## Product Change Notification

### PCN-PCC-262-2017

Business Unit	Product Line Code	Type of Change	Action	Date of Issue
PCC - PCB Connectors	AAC	Product Change Notification	Notify Distributors and Field	2/3/2017

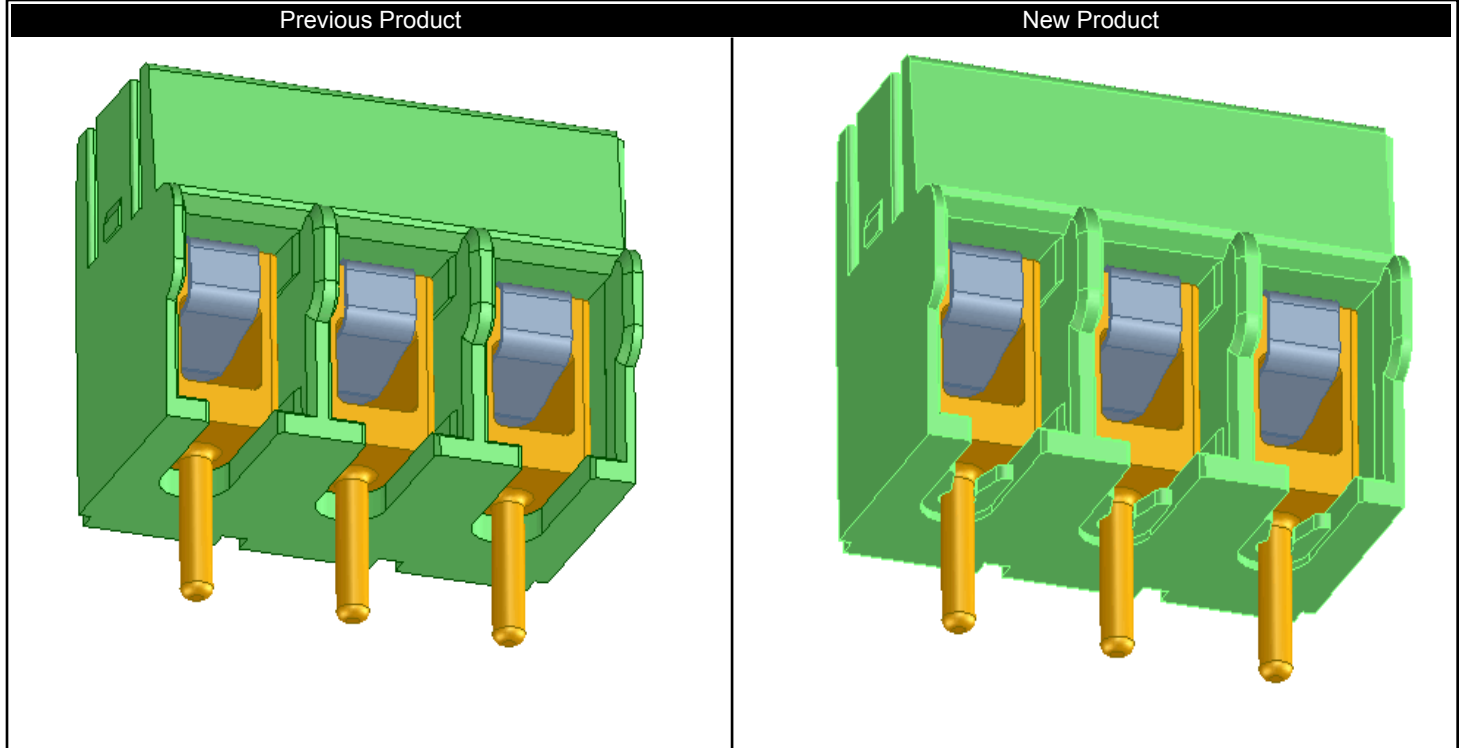
The fixed solder pin connection has been improved for PT 1,5-5,0-H. The design of the vertical versions will be updated analogously. Technical characteristics are not influenced by this change in any way. Part numbers also affected: 1844497 1992573 1768156 1990601 1991228 1712730 1712731 1701355 1746990 1991354 1704644 1737938 1737941 1706341 1992586 1988422 1715015
